Autoclass margin (D3.1) v100

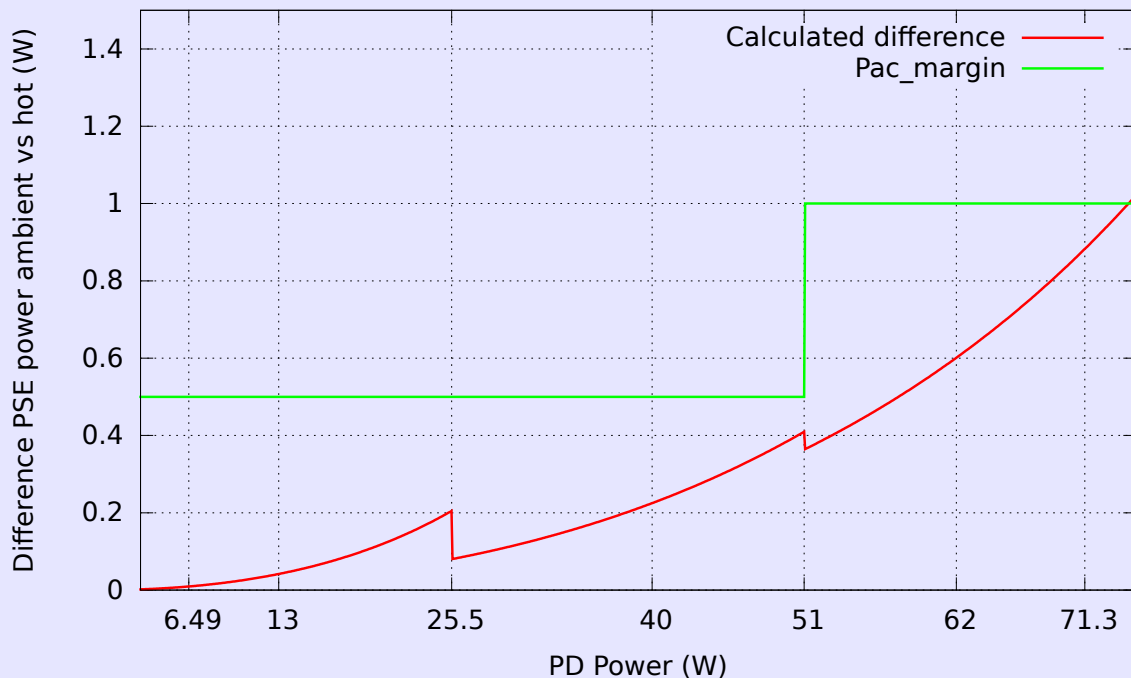
Recent better understanding of real-world worst-case cable conditions and heating led to recalculating and discovering that the minimum Autoclass margins can both be simplified, getting rid of the quadratic curve-fit equation, and be significantly reduced. In the revised calculation the following assumed:

- PSE voltage at minimum (50V for Class 1 through 6, 52V for Class 7 through 8).
- The link section is comprised of 90 meters of AWG 24 and 10 meters of AWG 26
- Two pair power is used up to Class 4
- Ambient temperature is set to 45 °C, and increased by 15 °C over the entire length of the cable.

Which leads to the following results:

The line 'calculated difference' is difference in power between the cables at 45°C versus the cables at 60°C. The line 'Pac_margin' is the new proposed value for P_{ac_margin} .

Add new item 4 into Table 145-15 and change title as follows:

Table 145-15 — Autoclass ~~timing~~ electrical requirements

Item	Parameter	Symbol	Units	Min	Max	Additional information
4	Autoclass power margin per the assigned Class					
	Class 1 to 6	$P_{\text{ac_margin}}$	W	0.5		—
	Class 7 to 8			1

Remove Equation (145-4) and associated variable description.
